CERTIFICATE OF APPROPRIATENESS

**RE: Application Number 20-6984; 439 Henry; Cass-Henry Historic District
Project Scope: Rehabilitate Apartment Building**

RE: 439 Henry Street—Bretton Hall

Sheet
4A102

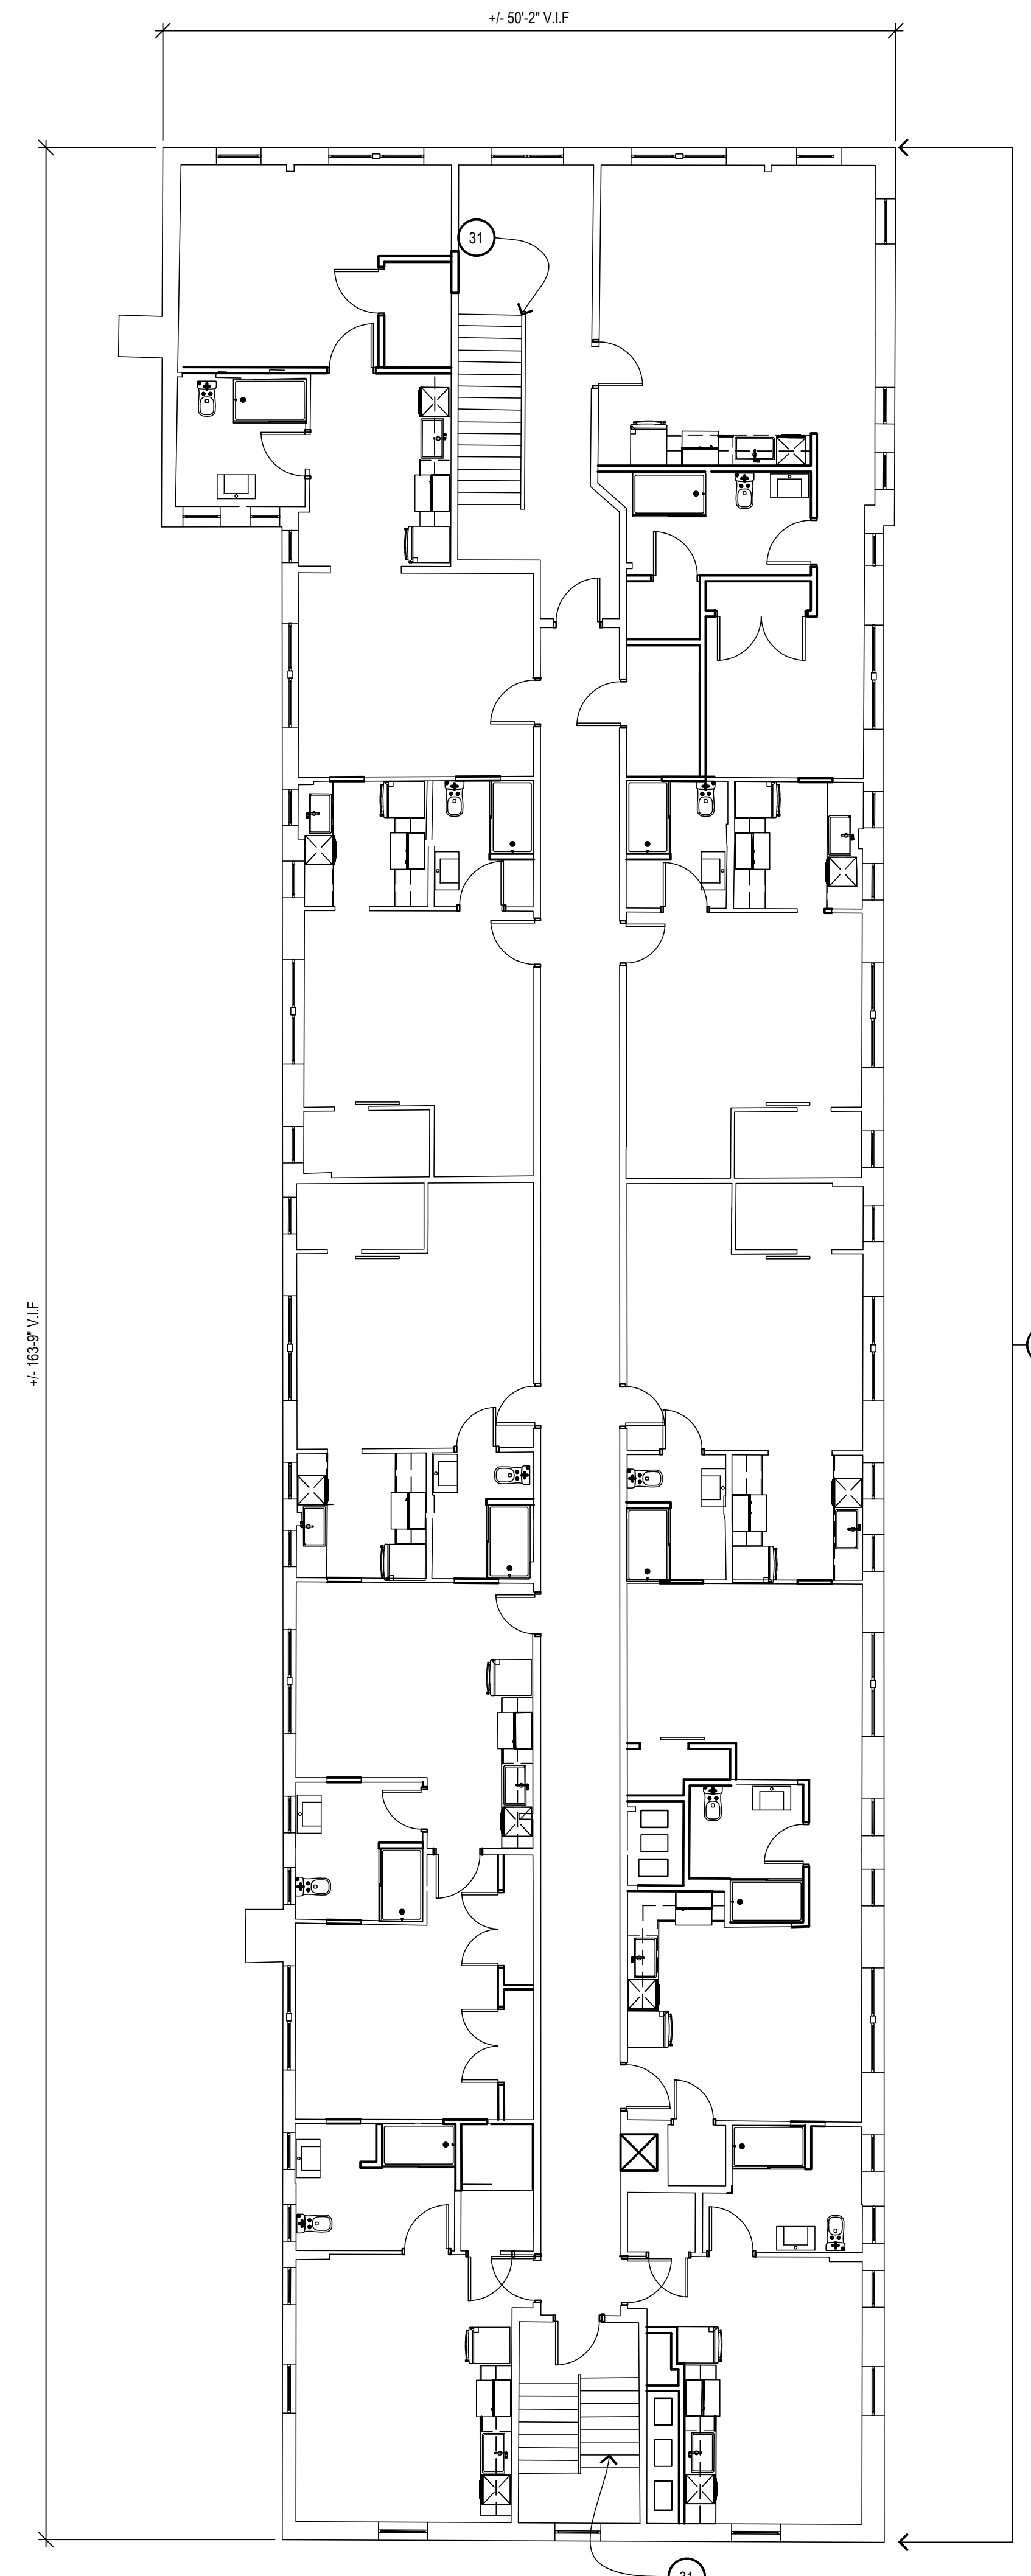
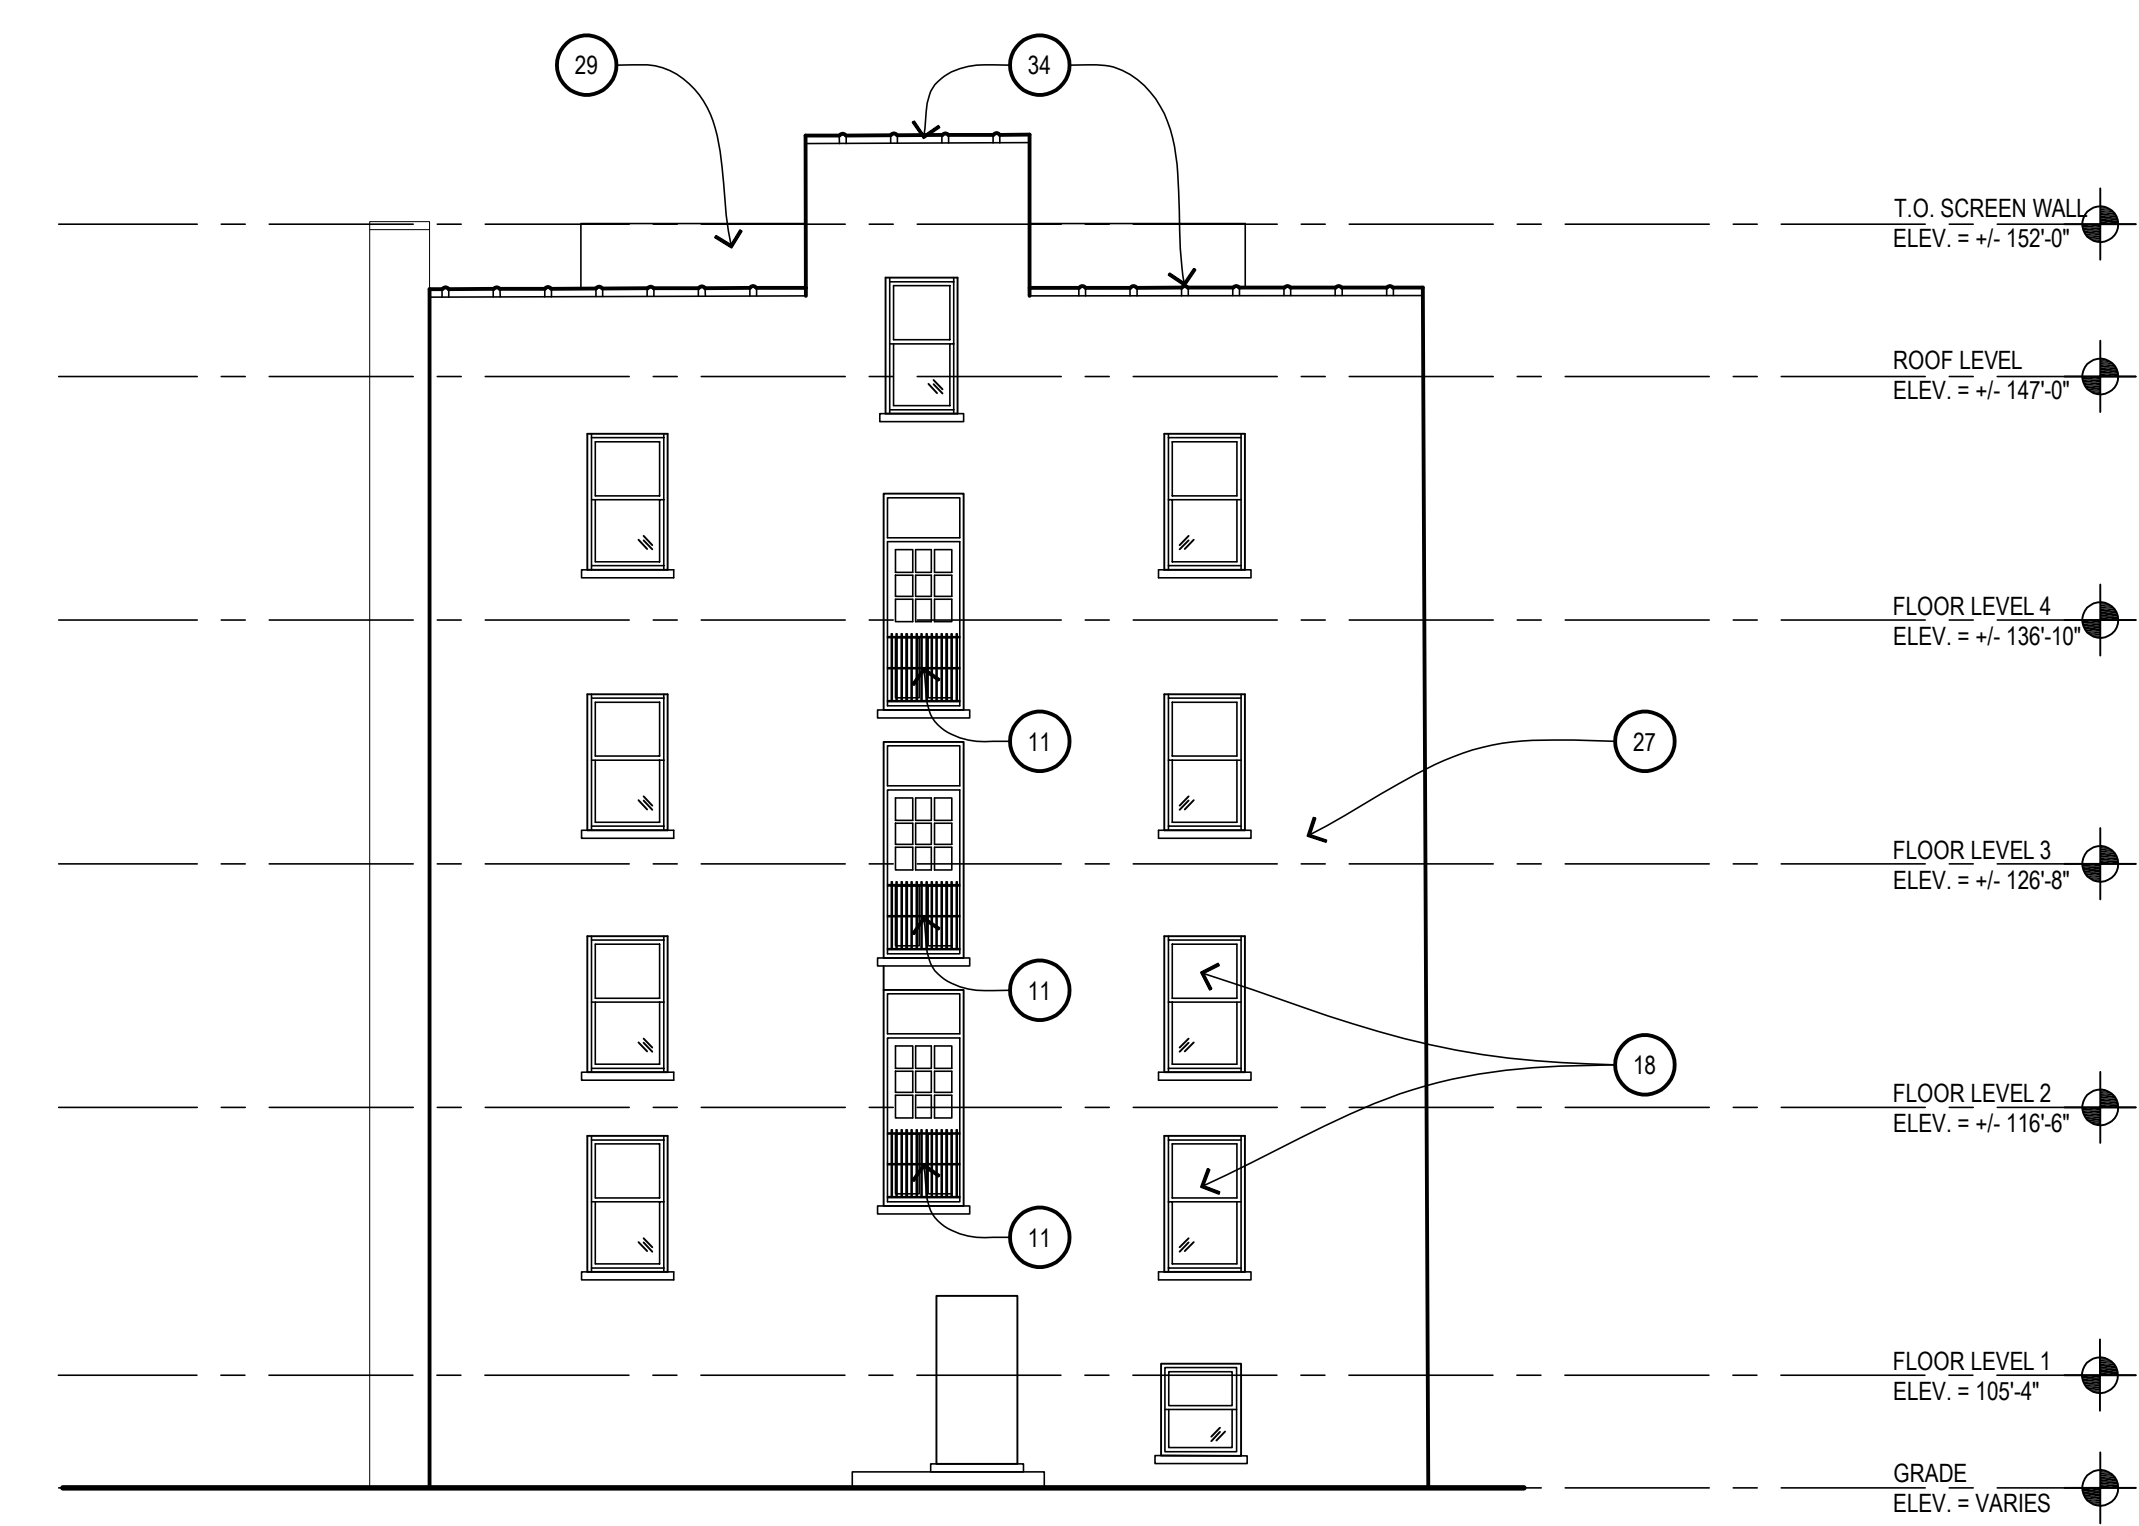
- *Current poor condition membrane roof to be removed and replaced with a new EPDM roof*
- *Small condenser farm will be added to the rear center of the roof and screened with an approximately 5' tall metal roof screen in a "Dove Grey" color*

And, as per the submitted documents, specifically drawings 4A101, 4A102 (floor/roof plans) and 4A401, 4A401.1, 4A402, 4A402.1 (elevations)
